Access Compliance Report

Public Rights-of-Way

(Curb Ramps)

Intersection ID: 4910	Main Street: ALBA_CT	Cross Street: GRANARD_LN	Location: NW
ADA ID: 14943D6655F6	Ramp Type: Perp	Initial Pass/Fail: Fail	Overall Compliance: No
Severity Score: 37.5			
Codes/Mitigation Info/Possible Solution		Field Measurements/Component Compliance

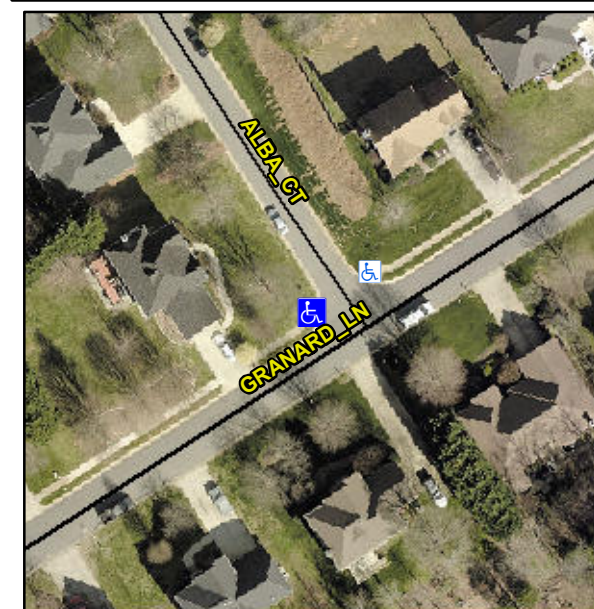
Not Found, R304.2.2, R304.5.3

Compliance	Description	Data	Compliance	Description	Data
N/A	Ramp Length (in)	48.0	No	Ramp Slope (%)	14.1
Yes	Ramp Width (in)	62.0	No	Ramp XSlope (%)	5.9
N/A	Flare Type LT	N/A	N/A	Flare Type RT	N/A
N/A	Flare Slope LT (%)	N/A	N/A	Flare Slope RT (%)	N/A
N/A	Flare Traversable LT?	N/A	N/A	Flare Traversable RT?	N/A
N/A	Landing Length (in)	N/A	N/A	DWS Provided?	N/A
N/A	Landing Width (in)	N/A	N/A	DWS Contrast?	N/A
N/A	Landing Slope (%)	N/A	N/A	DWS Length (in)	N/A
N/A	Landing X Slope (%)	N/A	N/A	DWS Full Width?	N/A
N/A	Landing Curb? (Y/N)	N/A	N/A	DWS Offset (in)	N/A
N/A	Shared Landing?	N/A			
N/A	Gutter Ponding?	N/A	N/A	Gutter Slope (%)	N/A
N/A	Gutter Lip Ht (in)	N/A	N/A	Gutter X Slope (%)	N/A
N/A	Painted X Walk1?	No	N/A	Painted X Walk2?	N/A
	X Walk 1 Direction	To NE		X Walk 2 Direction	N/A
N/A	X Walk 1 Width (in)	N/A	N/A	X Walk 2 Width (in)	N/A
	X Walk 1 Slope (%)	13.2		X Walk 2 Slope (%)	N/A
	X Walk 1 X Slope (%)	2.3		X Walk 2 X Slope (%)	N/A

Remove & Replace Entire Ramp.
